Reduce the existing building area to include a two tenant space and remove 1 parking space.

Re: Agent Authorization Notice – 2100 Louisiana Blvd. NE (Winrock Town Center)

RE: 1002202 - WINROCK TOWN CENTER - BLVD. NE – ALBUQUERQUE, NM 87110 – ADMINISTRATIVE AMENDMENT TO EXISTING PAD SITE AND ELEVATIONS

2 SITE PLAN
SCALE: 1" = 20'

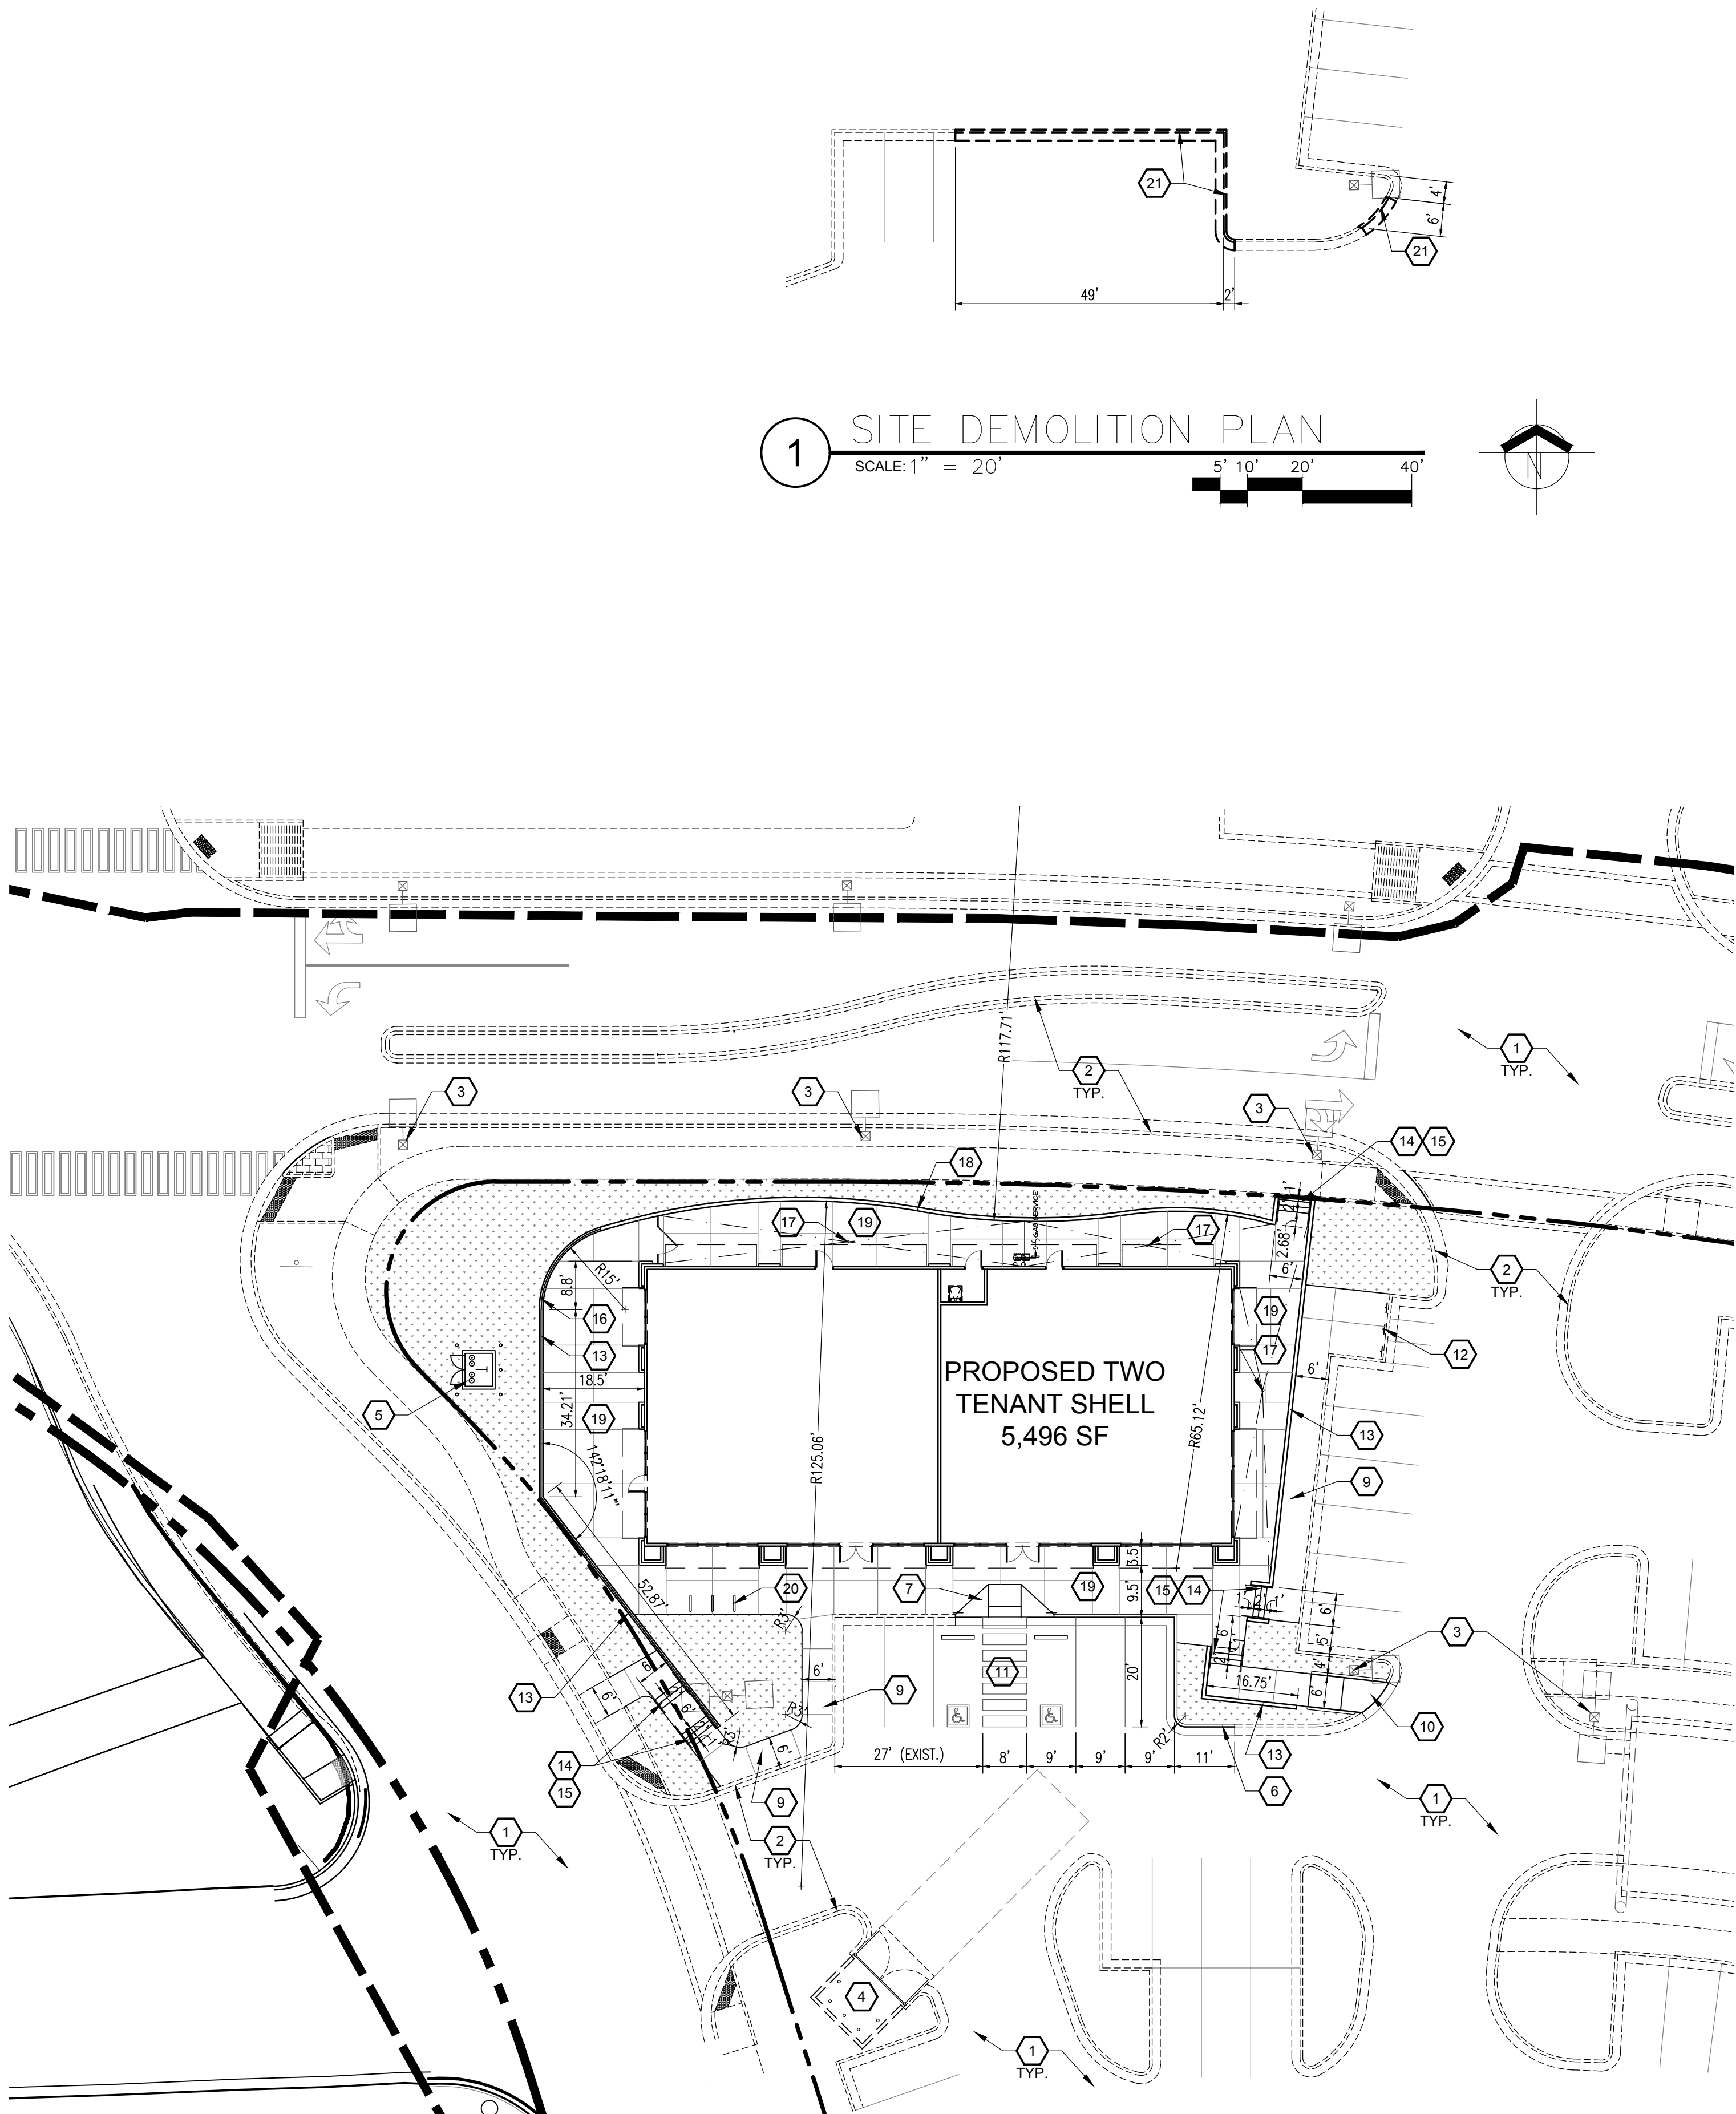
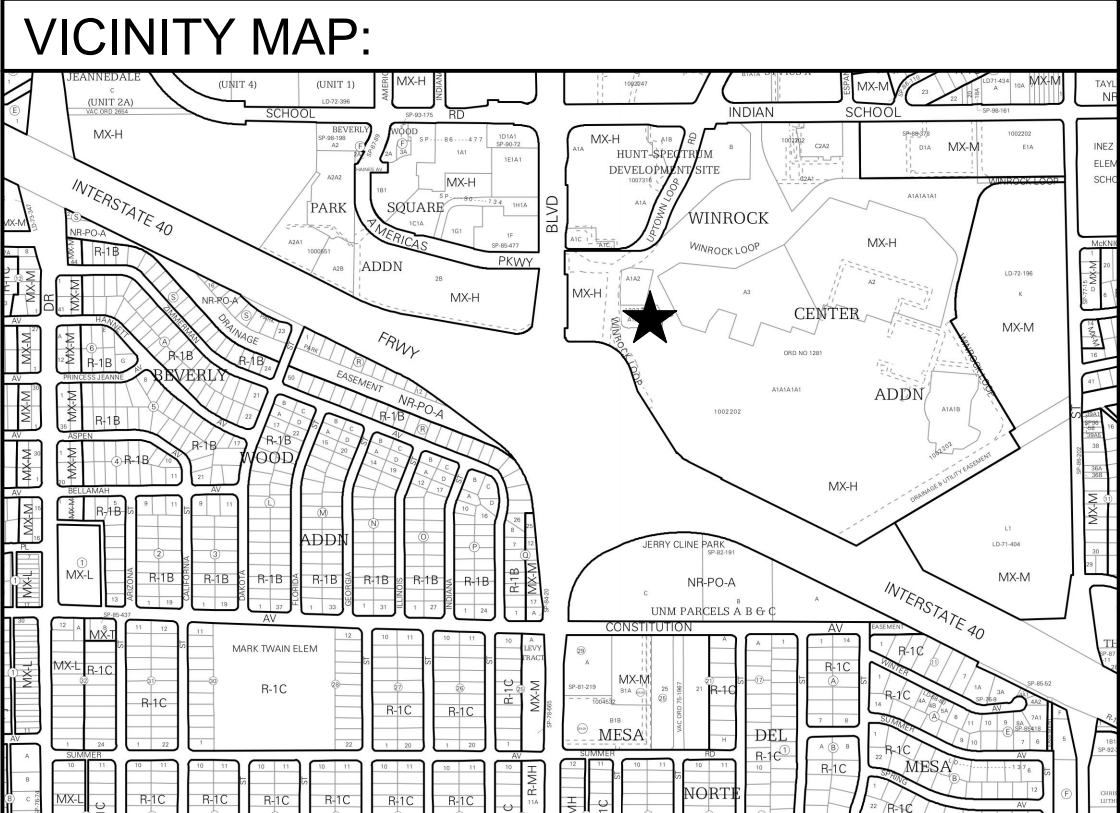
- The previous building was 6,500 SF and the new building is 5,496 SF.
- The building is being modified from 1 tenant to 2 tenants.
- There will no longer be an outdoor patio for the use.
- We shifted the ADA parking to the west 9' and removed one parking space in front of the building to make the grades work.
- Parking Calculation – We have not created a deficiency in the parking requirements and that is demonstrated on the Site Plan (Parking Data).
- Note: Existing parking and driveways to remain.

1 SOUTH ELEVATION (FRONT)
SCALE: 1/8" = 1'-0"

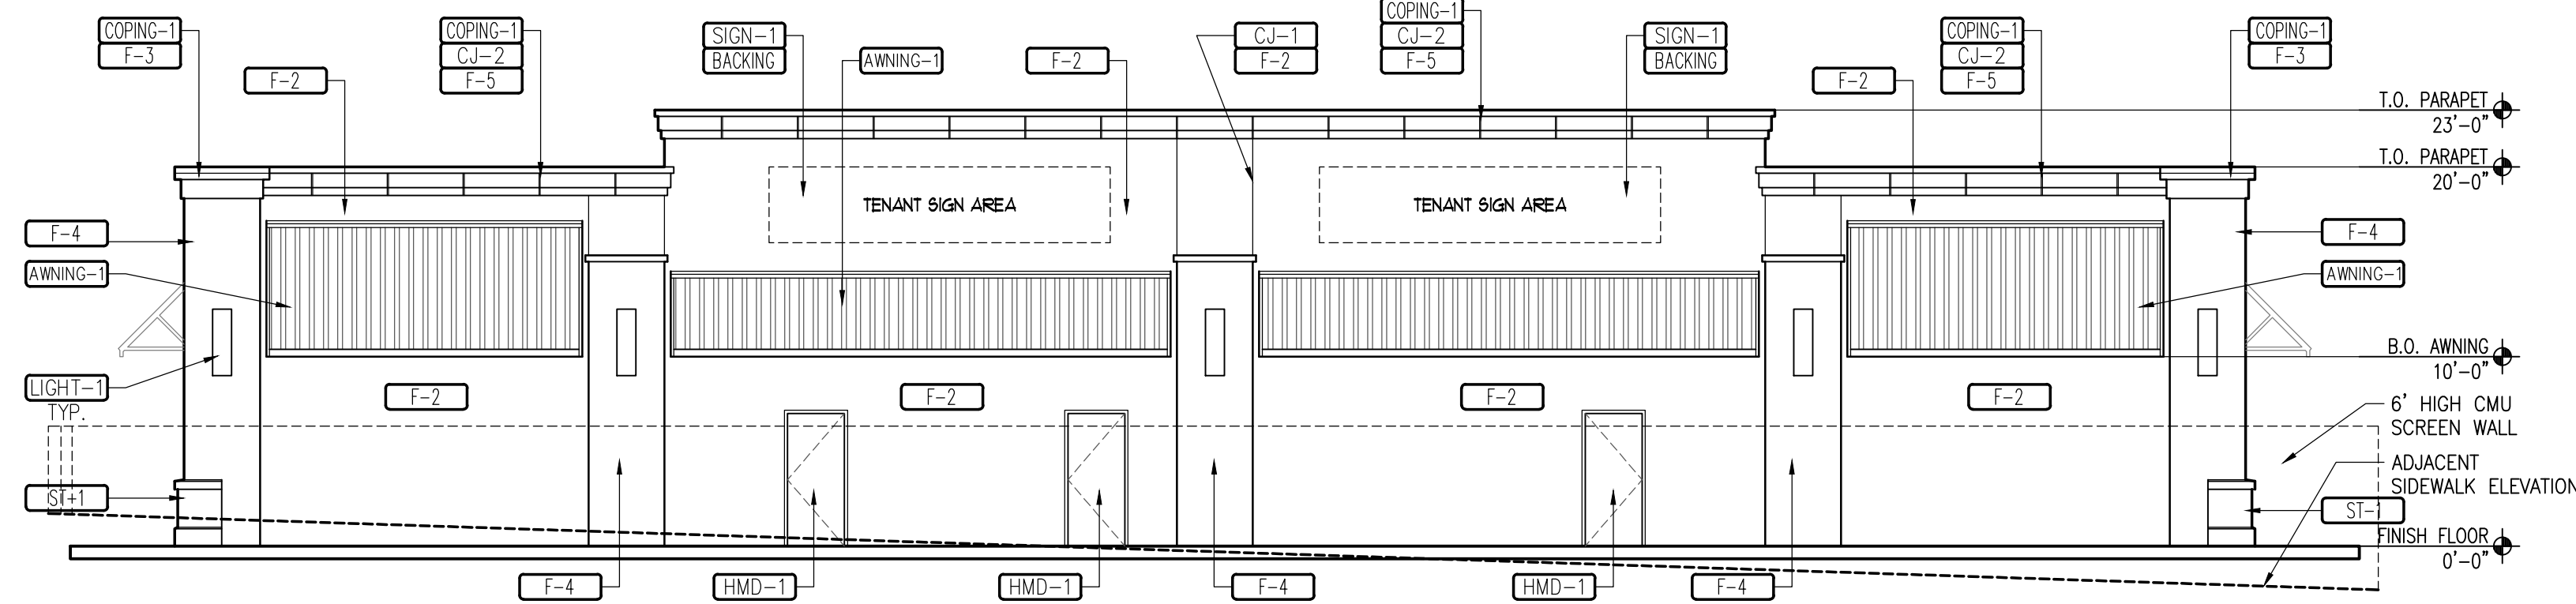
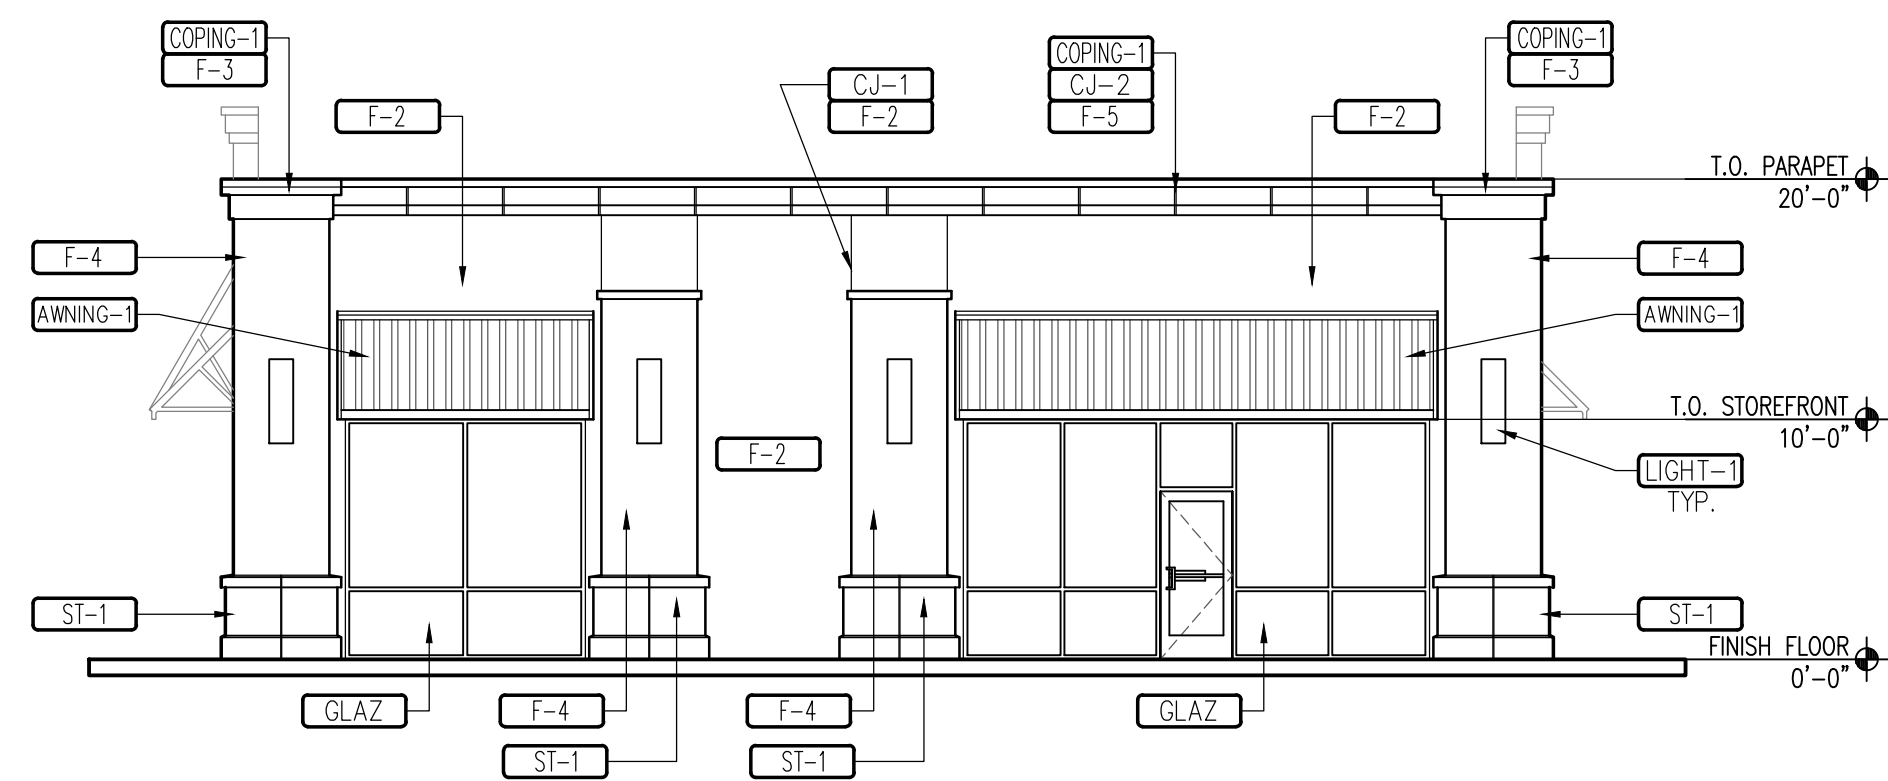
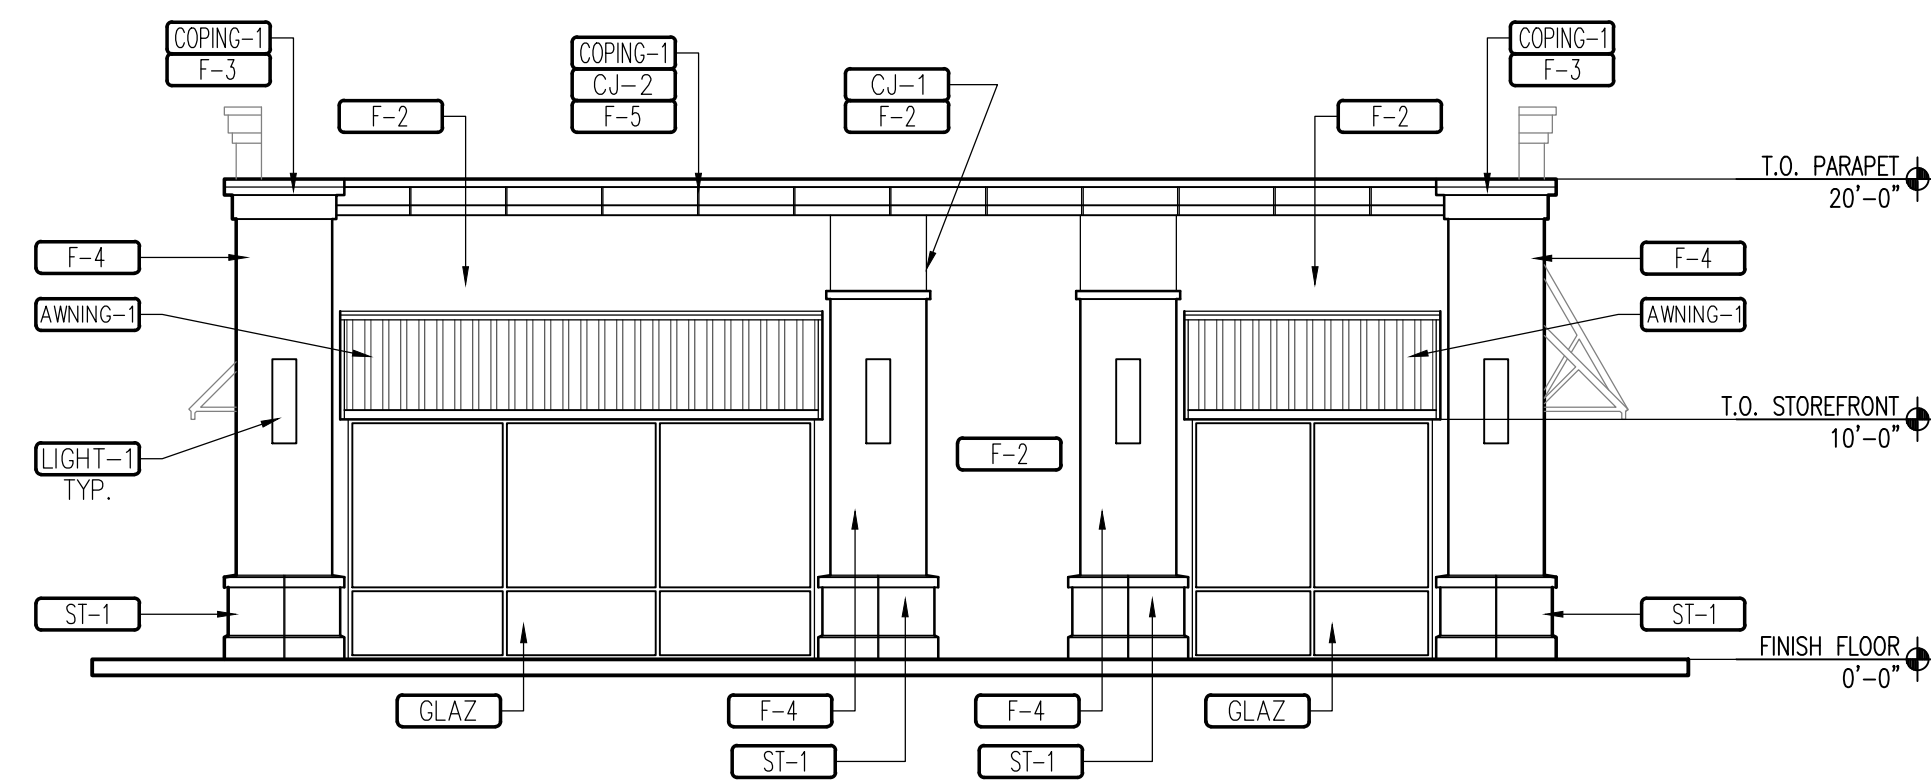
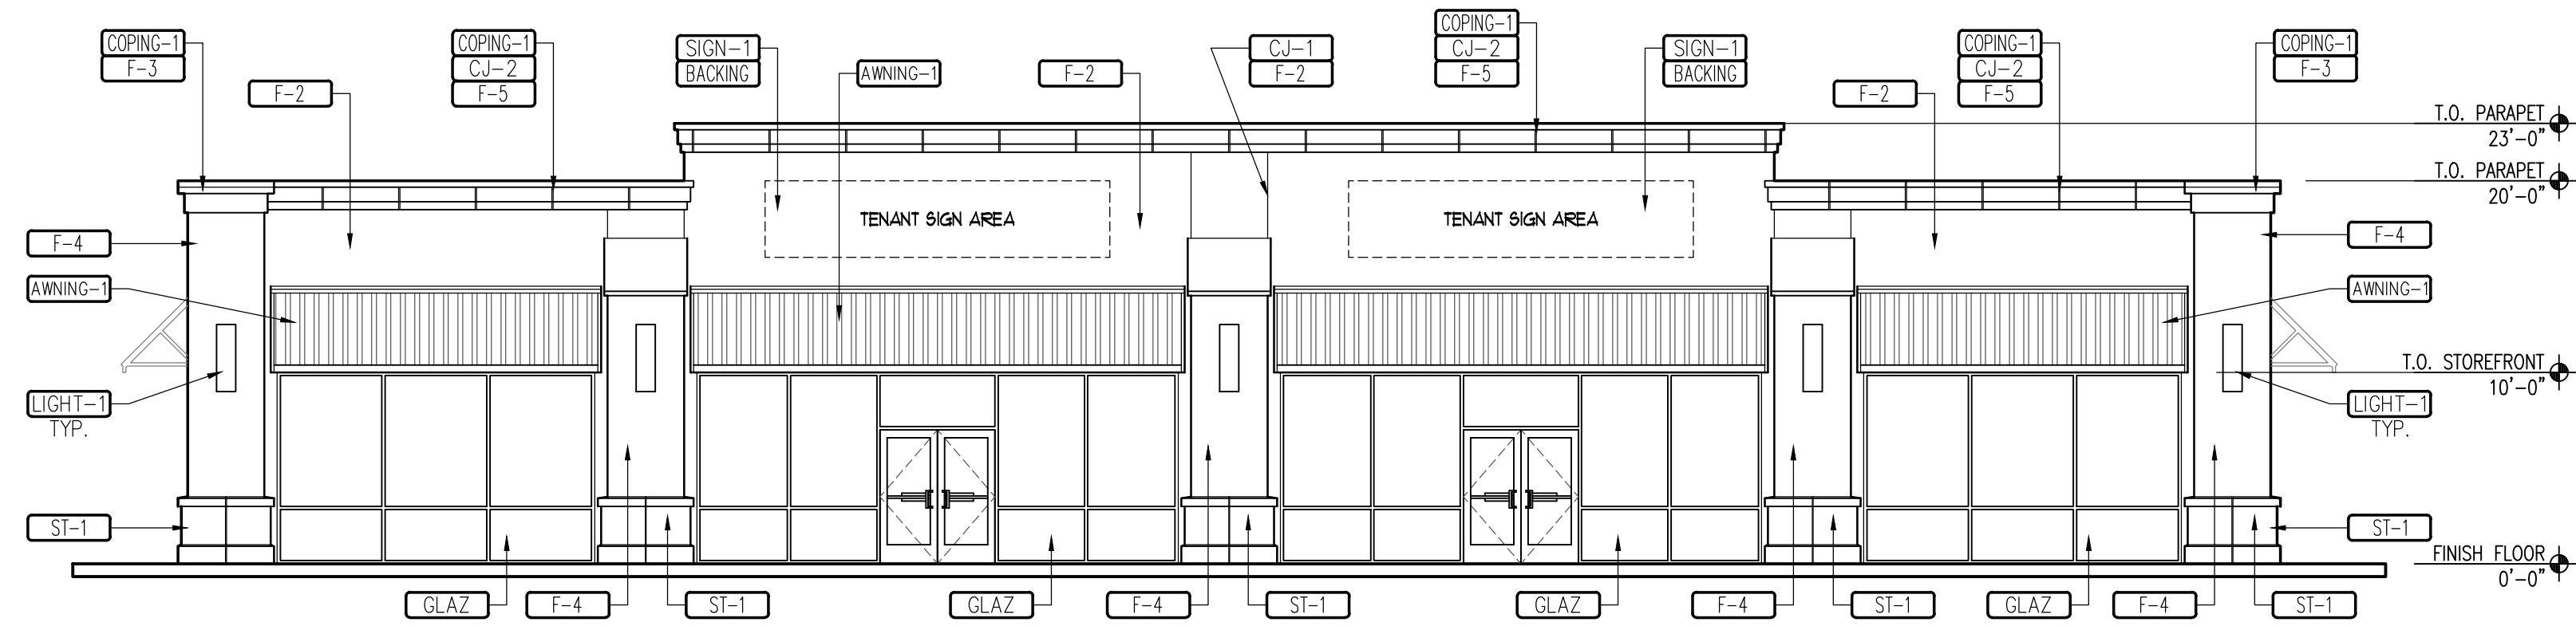
- The changes to the elevation reflect the two new users.
- The proposed signage is shown on the plans.
- The color and material are identified on the plan.
- The facade meets the requirements of 14-16-5-11(E).
